MEMORANDUM

RE: **DRH16-00079/ BVGC Parcel B, LLC**

Public Worksession DRH16-00079/ BVGC Parcel B, LLC

Approval for the construction of a six-story 145,000 square foot office building, a 5,000 square foot retail building, and a four-story 611 stall parking garage including 10,000 square feet of ground floor commercial space.

Sheet No.: SP100

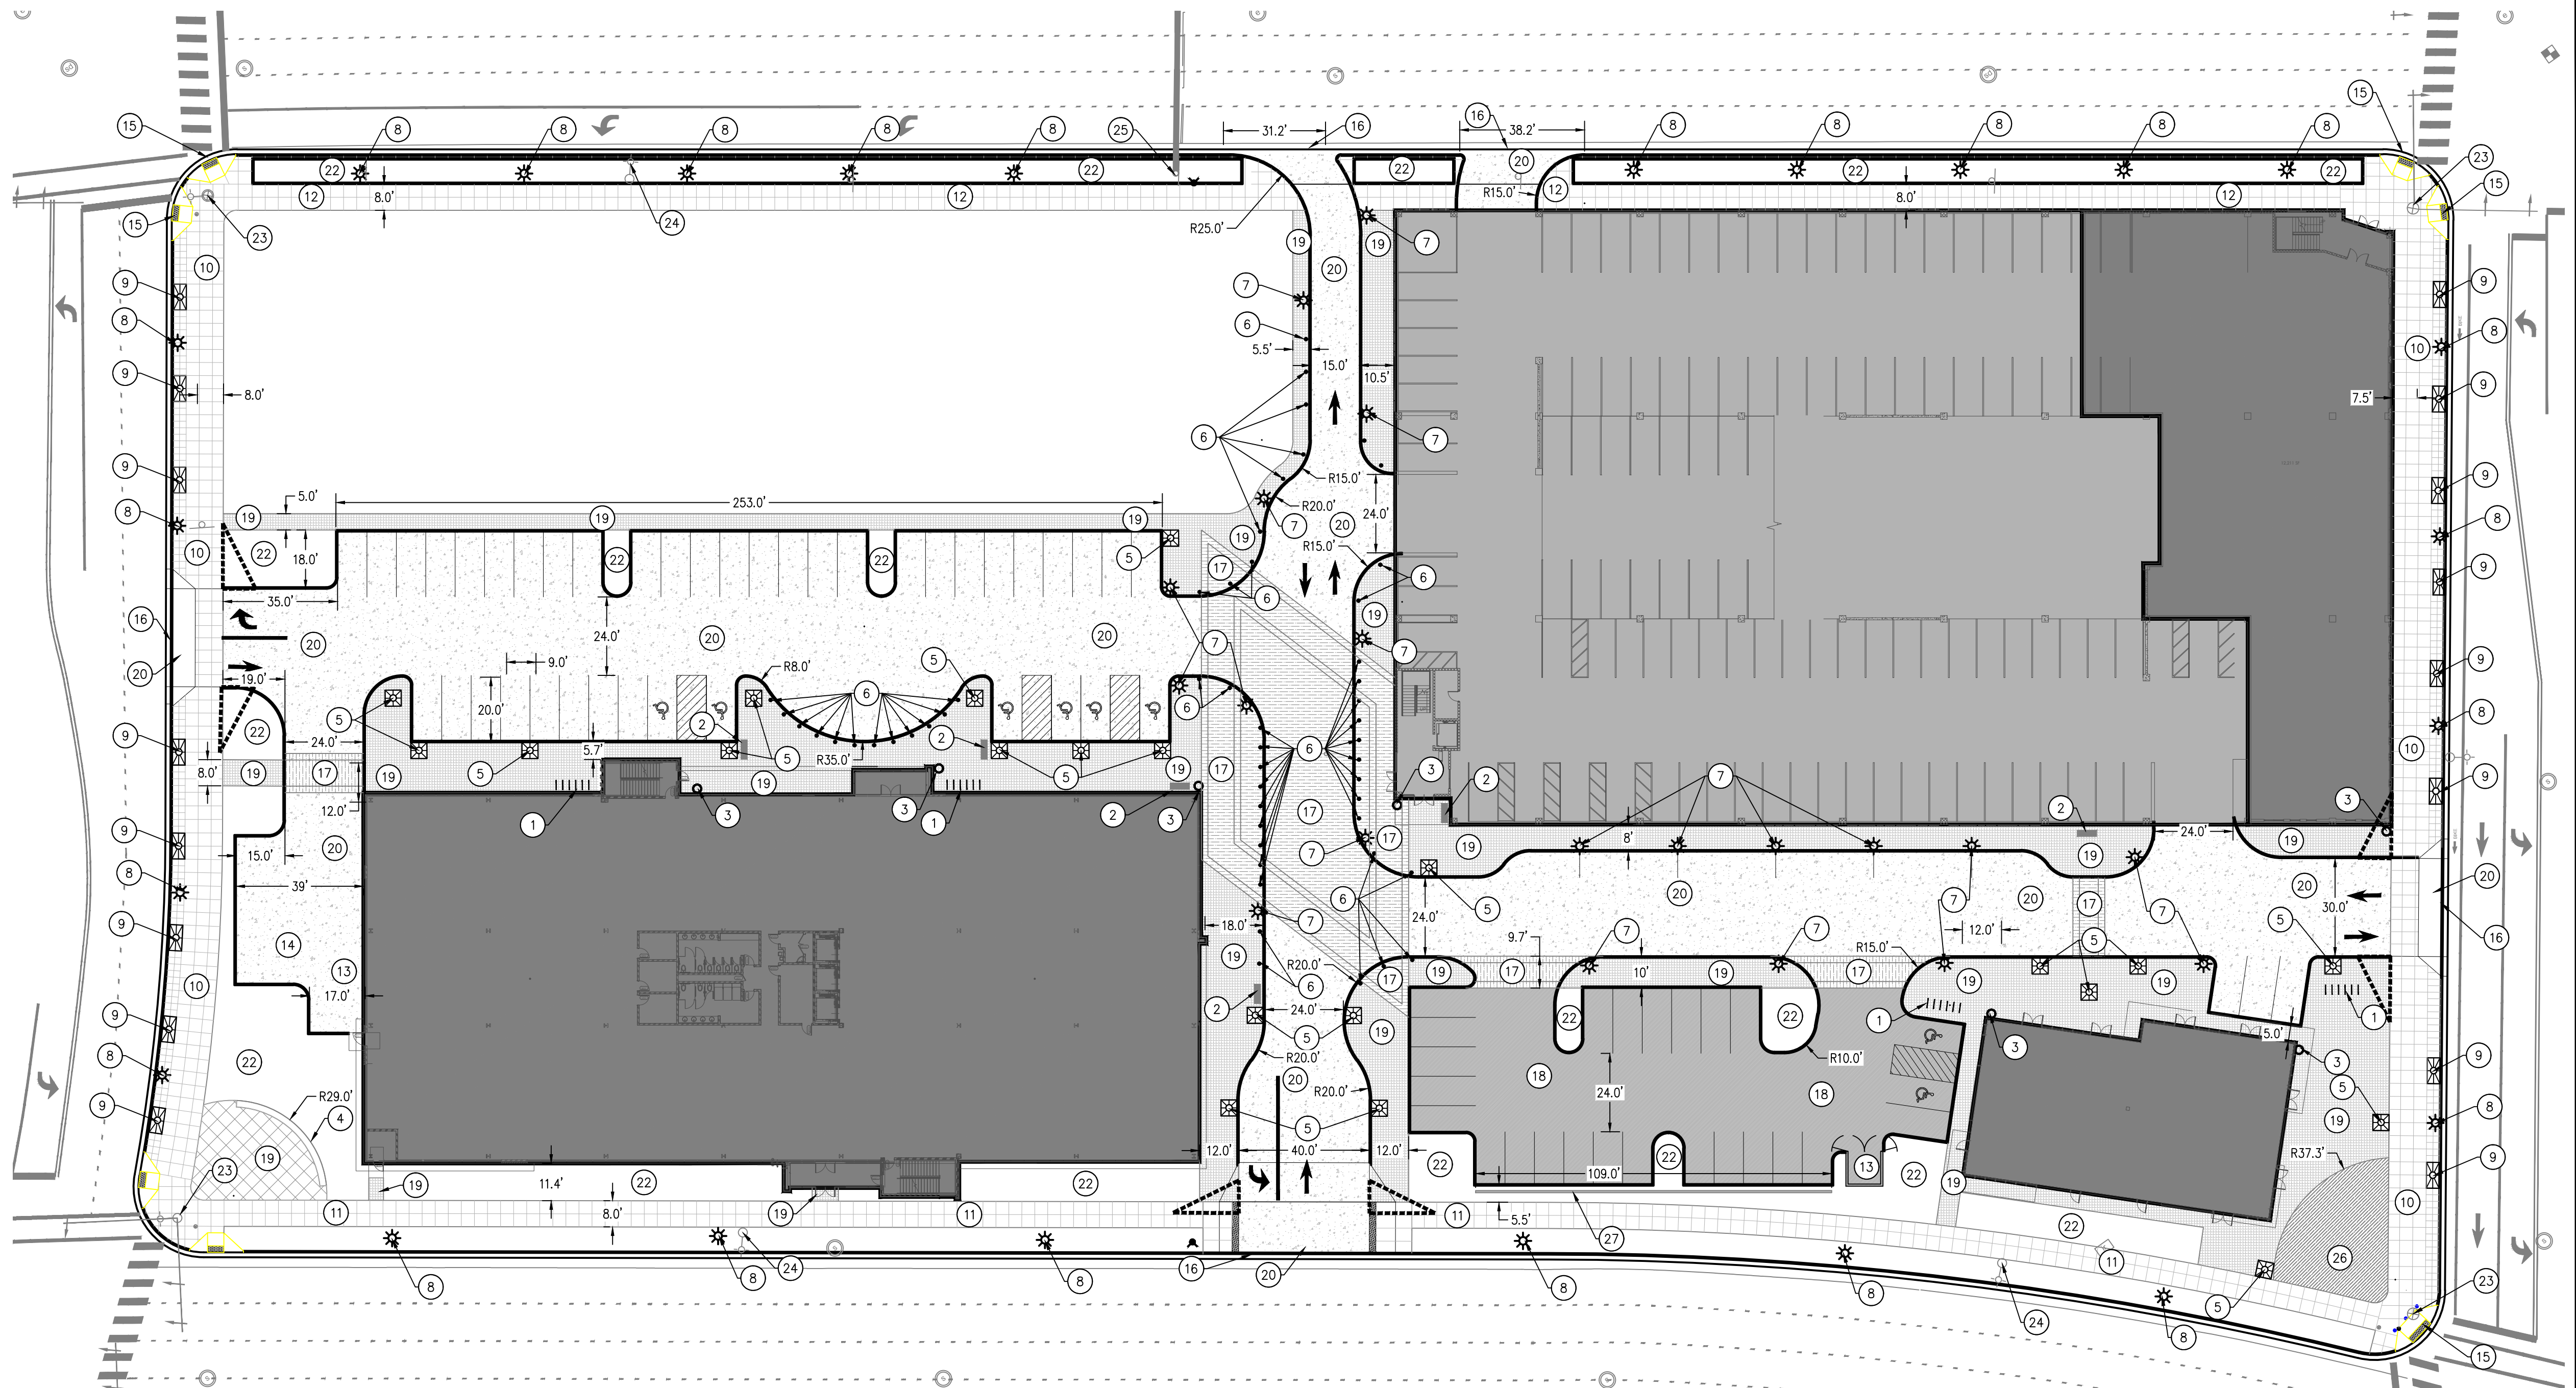
- 1c. Provide a sidewalk connection from the west end of the Retail Building to Myrtle Street.**

- 1d. Provide a three-foot high masonry wall between the Retail Building parking lot and Myrtle Street.**

1c. Provide a sidewalk connection from the west end of the Retail Building to Myrtle Street.

1d. Provide a three-foot high masonry wall between the Retail Building parking lot and Myrtle Street.

This has been done and is depicted on the revised site and landscape plans.

This has been done and is depicted on the revised site and landscape plans.

This has been done and is depicted on L100 and SP100. Additional discussion of this change is above regarding Condition 1a.

This has been done and is depicted on L100 and SP100. A detail depicting the three (3) foot tall masonry screening wall is included in SP100.

L100

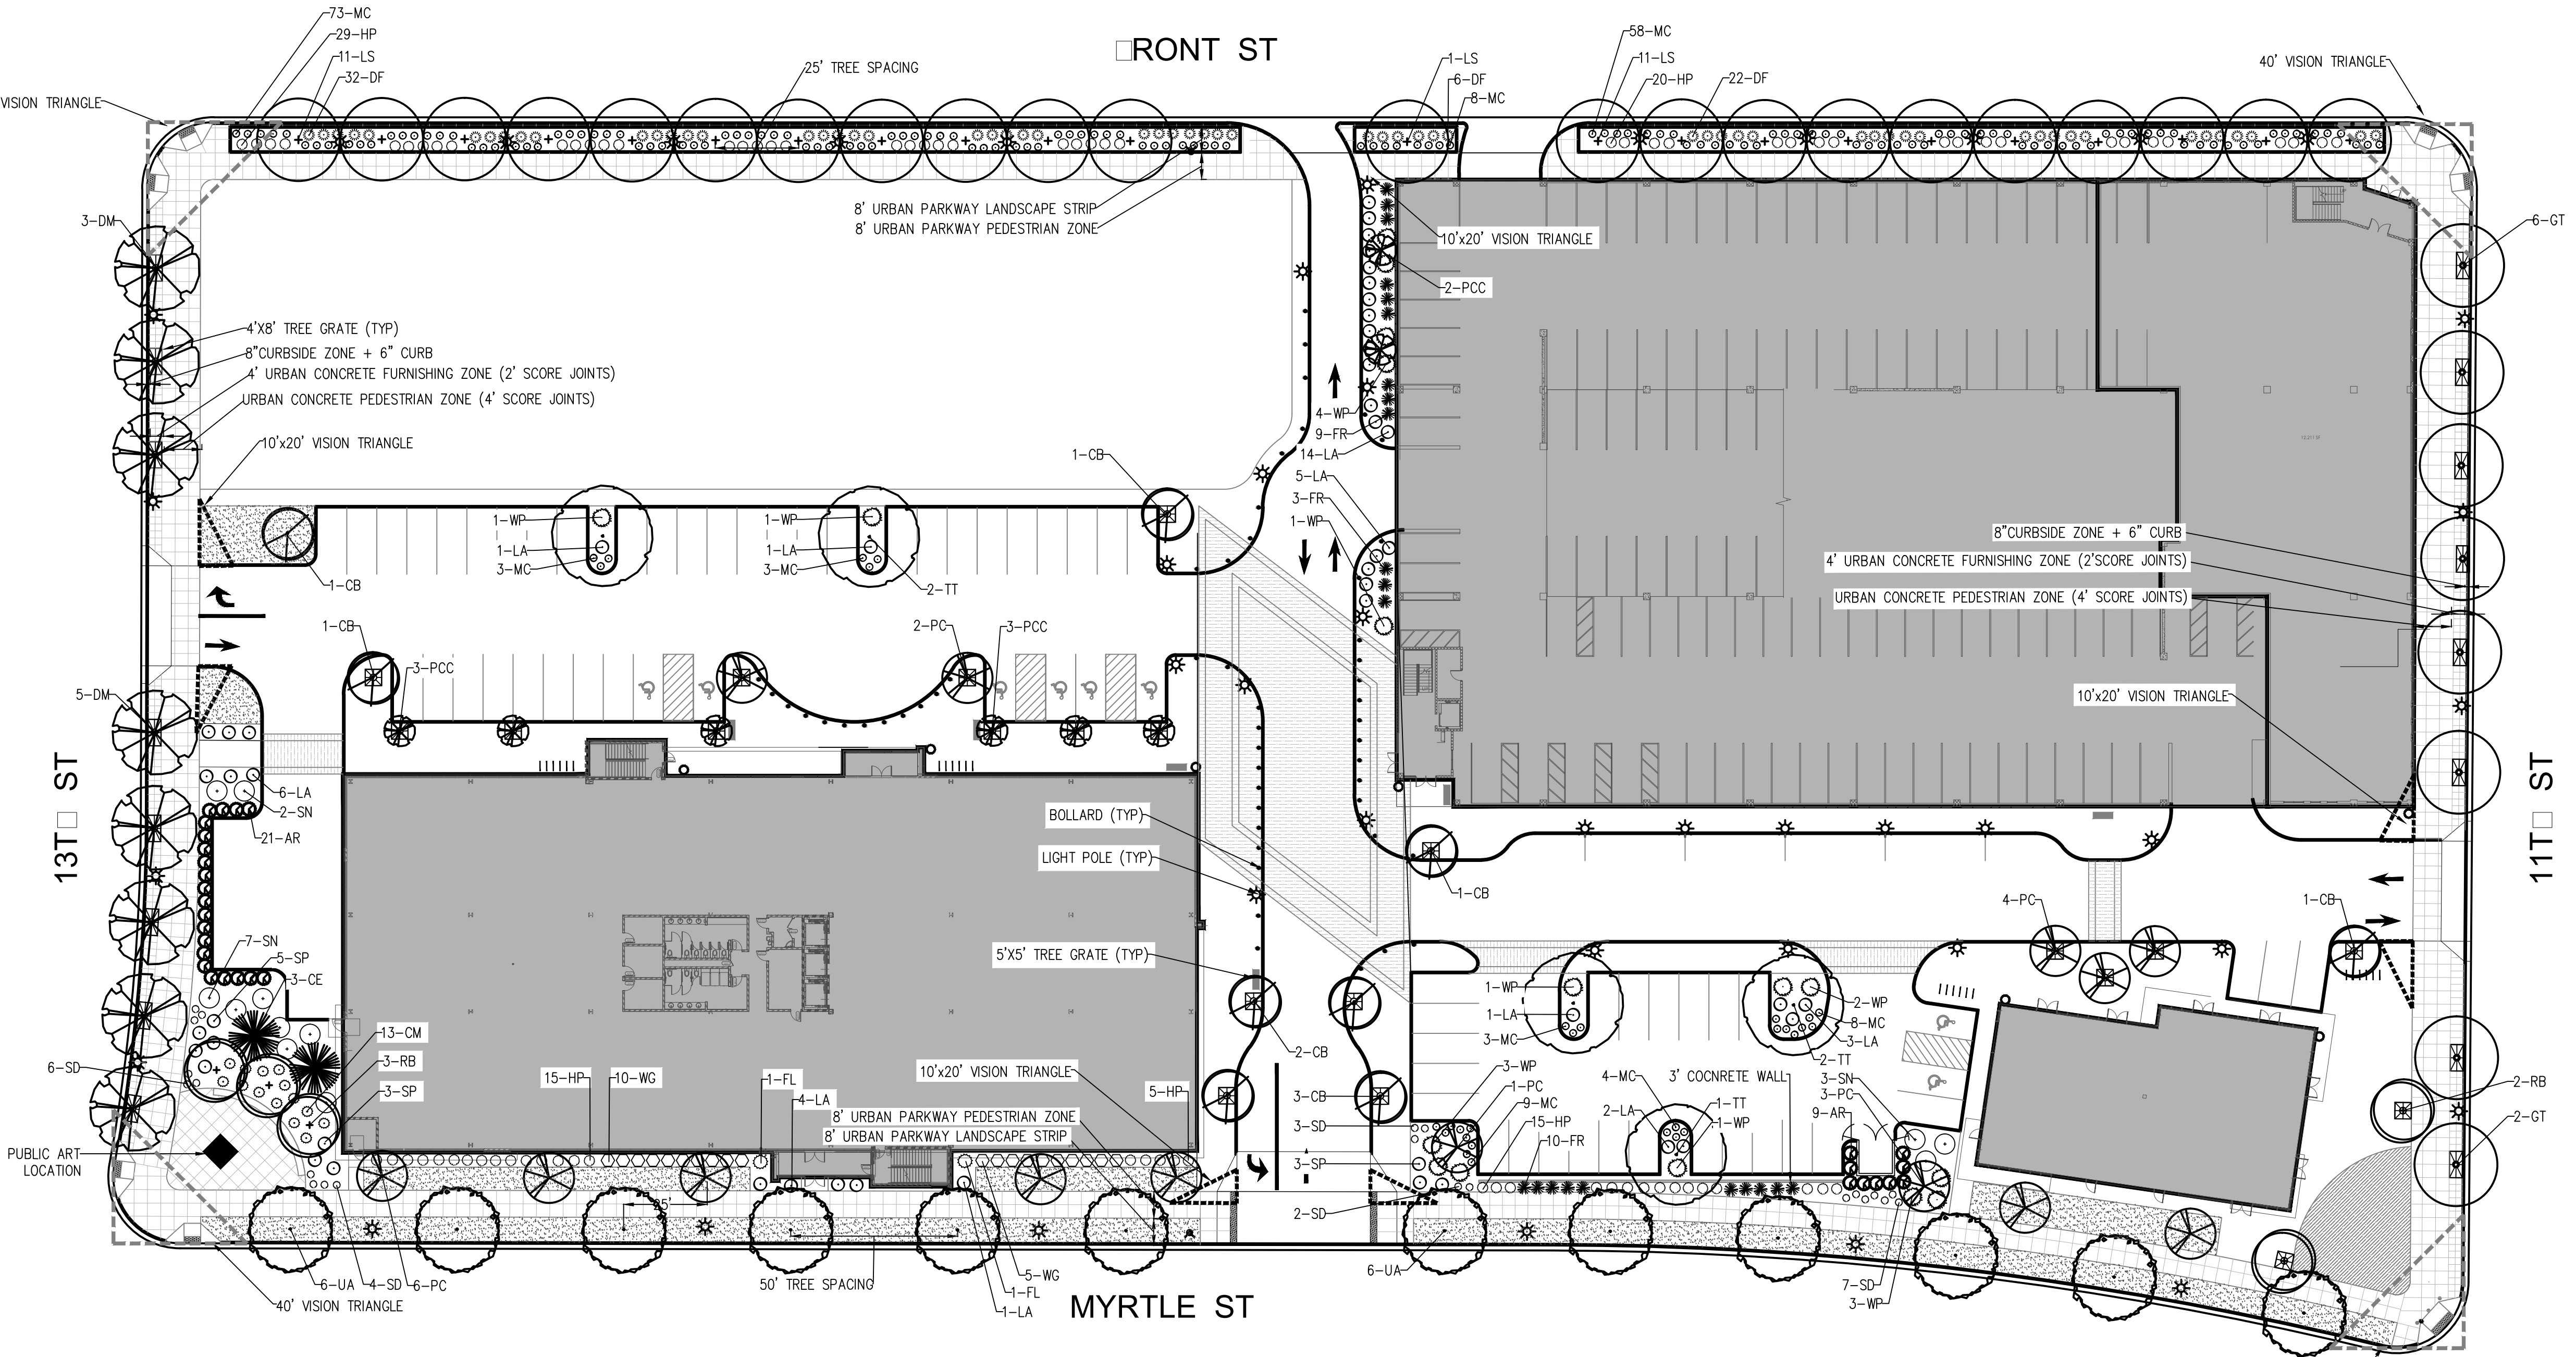
- 1a. Provide refined designs for the two public plazas incorporating public art, additional plantings, water features, or other design elements. Designs shall be reviewed by the Committee at a public work session.**

The applicant's revised landscape plan, Sheet L100, depicts changes to both plazas: the intersection of 13th Street/Myrtle Street, and the intersection of 11th Street Myrtle Street. Public art, a seating wall, and additional trees have been added to the 13th Street/Myrtle Street plaza, providing a more enhanced focal point for vehicles exiting the connector. The 11th Street /Myrtle Street plaza has been modified to be larger, includes sidewalk connections to the retail building, includes enhanced landscape screening of the service areas, and the seat wall has been eliminated to enhance the connection to the Pioneer Corridor.

1a. Provide refined designs for the two public plazas incorporating public art, additional plantings, water features, or other design elements. Designs shall be reviewed by the Committee at a public work session.

The plaza on the southwest corner at 13th Street and Myrtle Street has been revised and we want to draw your attention to the following details:

- We propose public art to be centered in the plaza as a focal point at this location;
- A concrete seat wall is shown between the plaza and the landscape area;
- More detail is provided of the landscaping area and the proposed plantings; and
- Additional trees are proposed behind the seat wall, these are a mixture of evergreens and flowering trees that provide greater color and contrast.

With the inclusion of public art at this location together with the enhanced landscaping and additional trees that are proposed for this plaza, we have significantly increased the screening of the Office Building from the intersection while providing additional interest and amenities at the pedestrian level, as depicted in the new perspective.

The plaza on the southeast corner at 11th Street and Myrtle Street has also been revised. We want to draw your attention to the following details:

- The plaza has been enlarged and opened up so as to provide a larger area for exterior seating to the east of the Retail Building and to provide better accessibility to it by pedestrians and from the Pioneer Corridor;

- The concrete seat wall originally proposed on this plaza has been removed because we determined that it created an unnecessary barrier to pedestrians between the sidewalk, the Pioneer Corridor, and the Retail Building;

- Sidewalk connections have been added at the eastern and western ends of the Retail Building to the sidewalk along Myrtle Street;
- The bicycle racks have been relocated to the north, again to provide a more open plaza and better connection between the Retail Building and pedestrians;

- On the west side of the Retail Building, enhanced screening and landscaping have been provided for the service facilities required for the building; and

- Additional evergreen and flowering trees have been placed adjacent to the plaza and the Retail Building to provide greater color and contrast.
